Certified Recommendation of the City of Raleigh Planning Commission

Case File / Name: SP-2-09/ NC Licensing Board General Contractors

Nature of Case: The proposed use is a 19,980 square foot two story office use zoned O&I-1 CUD on a 2.73 acre tract. Currently there is an existing building and tennis court which will be demolished with the approval of this site plan. Pursuant to rezoning condition J of Z-23-07, development of the subject property will require site plan approval by Planning Commission and City Council.

Proposed Site Plan

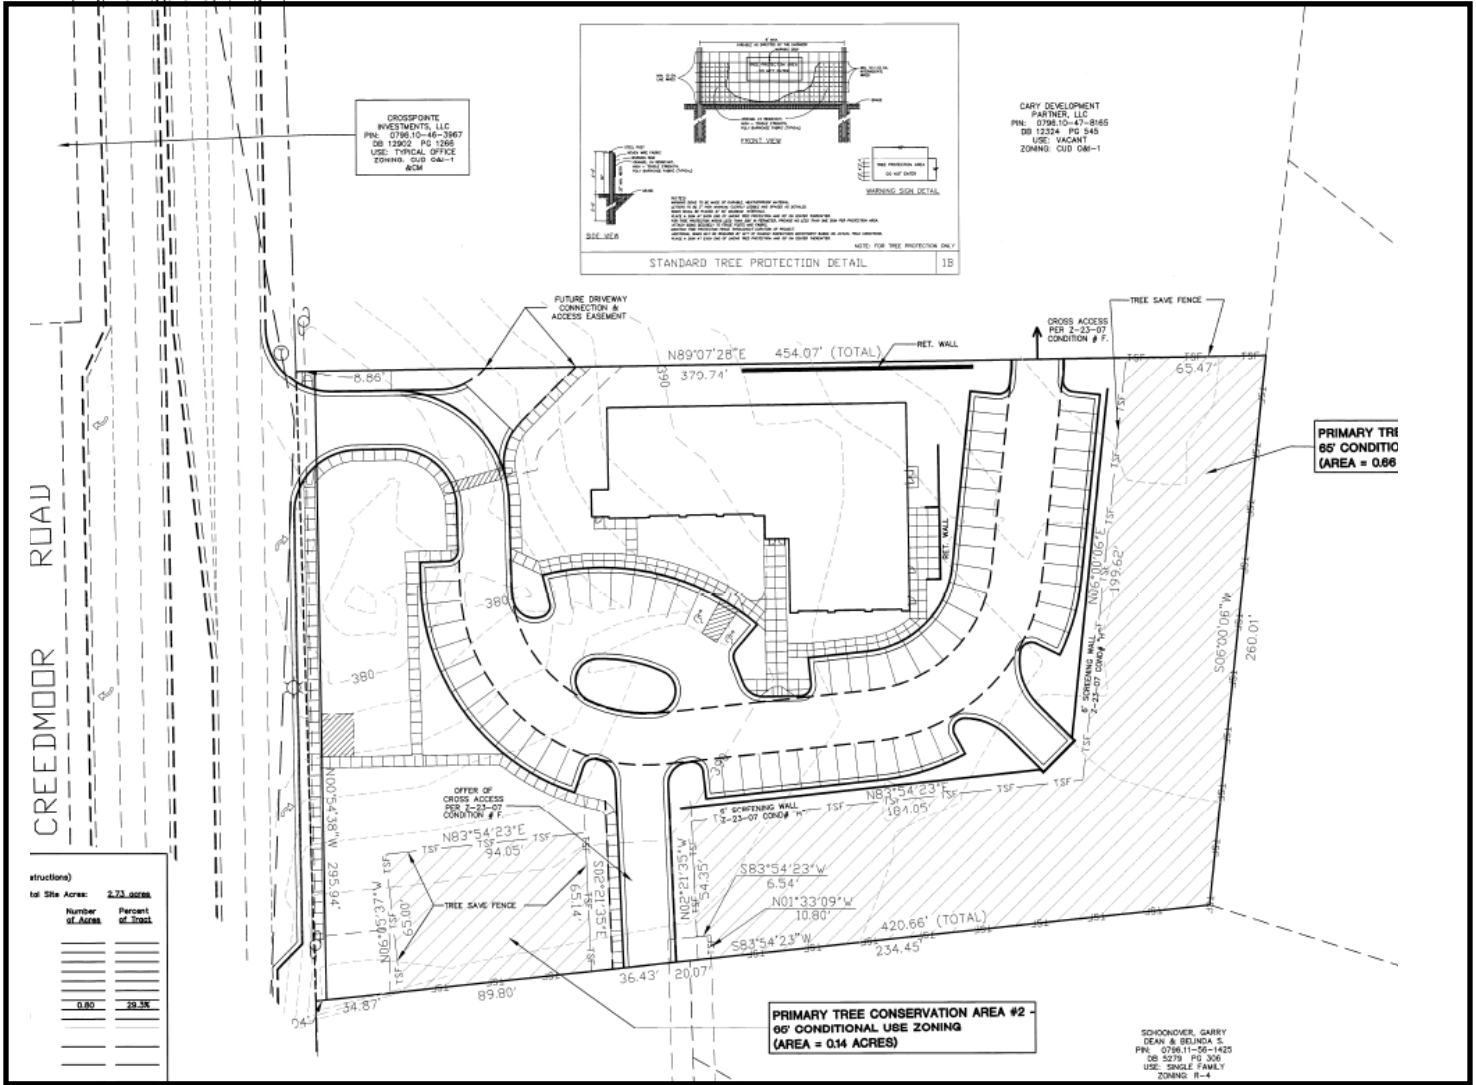
Key Issues: As presented, staff finds that this plan conforms to Code standards, rezoning conditions and adopted land use policies.

HEIGHT: This plan conforms to all minimum setback standards. Front yard = 128', rear yard = 155', front / rear aggregate = 283', side yard = 20 and 153', side yard aggregate = 173'. This plan conforms to maximum height standards in this zoning district of 40', proposed building height is 34'.

PARKING: Off-street parking conforms to minimum requirements: 67 spaces required, based on 1 parking space per 300 s.f. office use. 67spaces are provided. Site is not utilizing 10% parking reduction allowed by City Code.

Total site 2.73 acres; 10% required = 0.27 acres of Tree Conservation Areas. Primary TCA provided = 0.80 acres. 65' wide tree conservation areas are located along south and east property lines consistent with condition Z-23-07.

Additional right-of-way to be dedicated is reimbursable at R-4 rates per Zoning Condition E of Z-23-07. This site is provided a 5' sidewalk the entire length of Creedmoor Rd. except for a small section on the south (approximately 30') which will require a fee in lieu and a 30' x 30' slope easement to be provided.

CIRCULATION: Proposed street improvements shall conform to normal City construction standards. Cross access easements will be required between the north and south adjacent properties and they will be required to be recorded prior to map recordation and / or building permit. A 24' cross access easement is shown allowing access from the adjacent lots to the north and south to gain access via this site plan onto Creedmoor Rd.

PEDESTRIAN: A sidewalk is required along both sides of Creedmoor Road. Proposed sidewalk locations conform to City regulations along the majority of the Creedmoor Road frontage. The sidewalk is terminated 30 feet short of the southern property line due to steep grades and will be required to be constructed with the development of the south adjacent property. Sidewalks are proposed internally linking subject site with parcels to the north and south and Creedmoor Rd.
